MITIGATED DETERMINATION OF NONSIGNIFICANCE (MDNS)

To: Karla Boughton, SEPA Responsible Official
From: Nikole Coleman, Associate Planner
Subject: SEPA DETERMINATION | Johnson Ridge PRD and Preliminary Plat | P-08-02-19-01
Date: June 8, 2020

Project Description: Develop 13.75 acres into 61 single family lot Planned Residential Development (PRD) and Preliminary Plat (PP). The average lot size is 5,041 SF and the smallest lot is 4,361 SF. 2.06 acres of open space is proposed. Improvements include roads, open spaces, recreational amenities, tree retention, and utility and stormwater facilities. Critical areas include an off-site wetland, steep slope, and Bjorgen Creek. The property is vacant following the removal of multiple dilapidated buildings (see Exhibit A).

The yellow highlighted area in the image to the left shows the 25-foot standard setback. The red line shows the extent of the construction area.

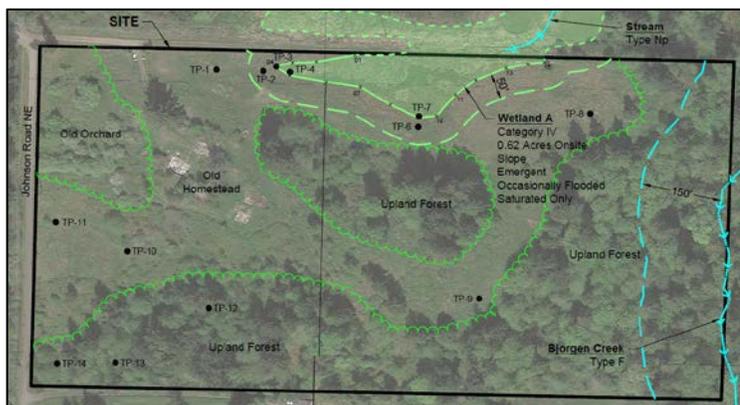
Based on the proposed Site Plan prepared by CPH Consultants, a small portion of the pervious trail and grading are proposed within the 25-foot standard setback area.

An addendum to the Geotechnical Report (Exhibit G) was requested by staff and provided in order to address this encroachment. Per page 1 of the GeoResources Addendum, “We analyzed a new cross section (Du-Du’) through the areas where grading will encroach into the required 25-foot buffer. The areas is generally limited to slope below proposed lots 3, 4, 5, and 6 on the east side of the development. A series of three walls will provide additional grade separation in this area, with grades being raised up to about 16 feet across these 4 lots. In our original report, slope stability section D-D’ was south of where the grading will occur within the buffer. As stated, we drew a cross section through Lot 4, where the greatest amount of fill will be placed. Using the same methodology and soil parameters described in our November 2019 report, the proposed configuration still meets or exceeds the minimum factors of safety of 1.5 and 1.1 against failure in a static and seismic condition, respectively.”

- “The proposed trail that goes through the 25-foot setback should be graded so that it does not convey or divert sheet flow to a single location. Instead, the trail/path should be graded such that runoff is evenly dispersed along the downhill side of the path.
- “Because it can take a year or two for the plants to establish themselves, using a spray-on mulch, such as Bonded Fiber Matrix, helps hold the soils around the plants in place until the new plantings mature. In lieu of a spray-on seed mixture, an erosion blanket such as coir fiber or jute netting could be used.”

The project buffer impact area is shown in green in the image to the left.

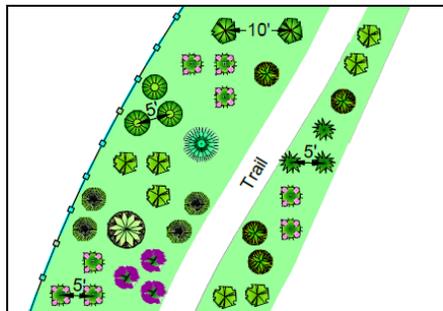
The project proposal was revised and now only includes grading impacts at the back of Lots 1 through 5 that will total 8,772 square feet and a portion of the trail is proposed within the 200-foot buffer area and will comprise 1,474 square feet of the buffer. Restoration is proposed to compensate for the impacts and will include installation of native trees and shrubs. The trail will be a 5-foot wide, gravel pedestrian trail within the outer edge of the 200-foot buffer per the PMC requirements.

The highlighted yellow in the image to the left shows the extent of the 25-foot building setback within lots 1-5.

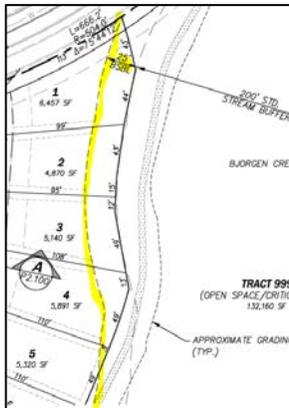
Per PMC 16.20.721, special reports shall be valid for a period of five years from the most recent date of issue identified on the face of the report. Therefore, after the 2020 Ecological Services Report expires, property owners in lots 1-5 will be required to submit an updated Habitat Management Plan if they wish to install minor structural or impervious surface intrusions within the 25-building setback area.

The image above shows the location of the storm vault in the SW corner of the development area.

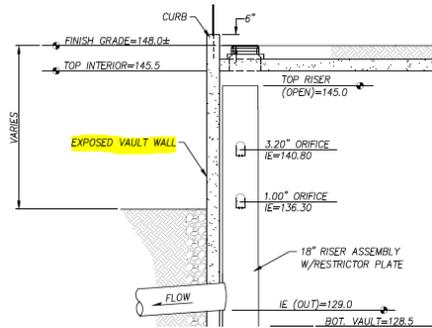
- a. The storm vault on the SW corner of the development proposes a 12-20-foot exposed retaining wall to be visible from the property to the south and the future Noll Rd corridor (coming from SR305).

Mitigation. Due to the significant aesthetic impact the exposed retaining wall will have on the residents to the south (current and future) and users (pedestrian, bicycle vehicle, etc.) of Noll Rd, enhanced landscaping that covers 30% of the exposed wall at full growth and artwork that is consistent with aesthetic scheme for the Noll Rd Corridor project shall be required. See also Engineering Department Memo.

10. Enhanced landscaping that covers 30% of the exposed retaining wall at full growth and artwork that is consistent with aesthetic scheme for the Noll Rd Corridor project shall be required. Review of the landscaping and artwork shall be reviewed at the time of tree cutting and clearing and grading permit.
